NUMBER: 23-002-13 REV. A

Rattle And/Or Clunking Sound From Convertible Top

2011-2012 (JS) Chrysler 200

Fig. 2 Down Capture Receiver Rod Replacement

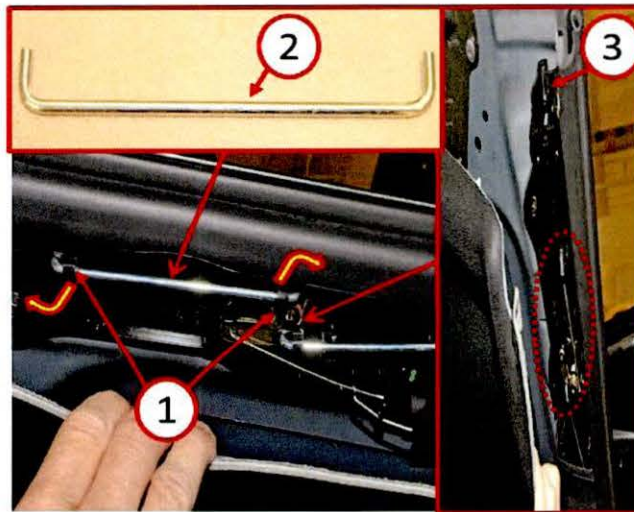
1. Pull the headliner back at the side weatherstrip seal on each side of the forward most hard top roof panel and inspect the forward most down capture receiver rod on each of the down capture latch assemblies.
2. Were either of the right and/or left side receiver rods bent and/or damaged?

- a. Yes >>> Proceed to **Step #3**.
 - b. No >>> Proceed to **Step #4**.
3. Replace the damaged or bent receiver rod(s) by swinging the retaining clips open and pulling the rod out of the clips (**Fig. 2**).

Fig. 4 Side Rail Down Capture Hook Replacement

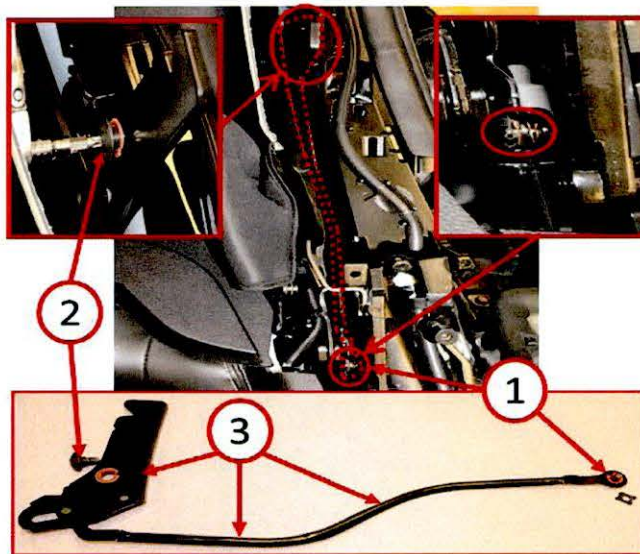
This bulletin involves inspecting the forward most down capture receiver rod on each of the down capture latch assemblies and if necessary replacing the receiver rod along with installing a revised down capture hook assembly.

-
5. Remove the push clip retainer and pin clevis (1) along with the torx shoulder bolt (2) (Fig. 4) to replace the side rail down capture hook assembly with the appropriate side/color specific revised part indicated in the parts section.
